*Proceedings of the Madras Government, Public Works Department,
15th January 1864.*

No. 308. Read the following letter from Lieutenant-Colonel A. J. M. BOILEAU, R. E., Superintending Engineer, 4th Division, to Colonel C. A. ORR, R. E., Secretary to Government, Public Works Department, dated Madras, 8th January 1864, No. 4,413:—

From Sir MACDONALD STEPHENSON, Civil Engineer, to Lieutenant-Colonel A. J. M. BOILEAU, R. E., Superintending Engineer, 4th Division, dated Madras, 4th January 1864.

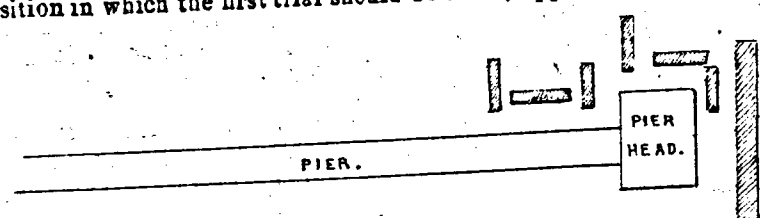
3. My want of experience in floating breakwaters does not warrant me in passing an opinion that can be considered as of any value in advising Government as to constructing such a frame work as is proposed by Sir Macdonald Stephenson, who, it will be observed, himself looks upon the matter quite in an experimental light. Certainly I do not think that such an experiment is at all likely to answer.

4. A recent writer observes with regard to this subject: "There have been submitted to the public of late years a great number of schemes for forming floating breakwaters, and wave-screens, or for employing some more economical system than that of creating as it were, artificial islands. But the marked failures of these ingenious contrivances have been so notorious, that it would be unnecessary here to discuss any of them."

4. The forms of breakwater are two-fold, the one used parallel and at right angles to the Pier, and at a distance to allow boats to lay inside, to be of 20 more or less balk-timbers of 20, 25 or 30 feet long, as most readily procured, and between each balk, two circular blocks of wood bound with sheet or loop iron and two mooring chains passing from end to end, through the timber and the blocks, by the buoys to the moorings. If the balks are of 2 feet section and 30 feet long the timber required will be about 30 feet for every foot run, exclusive of the blocks.

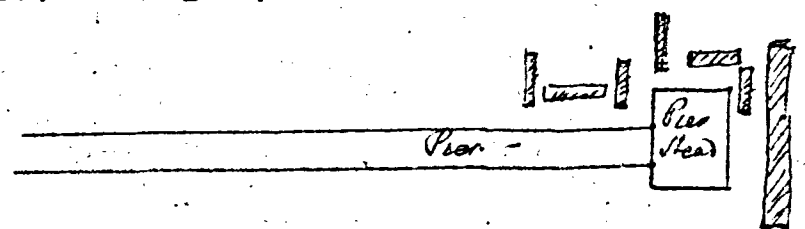
The forms of breakwater are twofold the one used parallel and at right angles to the pier, and at a distance to allow boats to lay inside, to be of 20 more or less balk timbers, of 20, 25, or 30 ft long, as most readily procured, - and

between each belt, two corner blocks of hard wood with sheet iron spurs; and two mooring chains passing from end to end, thro' the timber & the blocks, by the buoys to the moorings. If the balks are of 2 feet section and 30 feet long the timber required will be about 30 feet for every foot run, exclusive of the blocks.

My want of experience in floating
Breakwaters does not warrant me in passing
an opinion that can be considered as of any
value in advising Government as to constructing
such a frame work as is proposed by Sir Macdonald
Stephenson, who it will be observed, himself

looks upon the matter quite in an experimental light. Certainly I do not think that such an experiment is at all likely to answer.
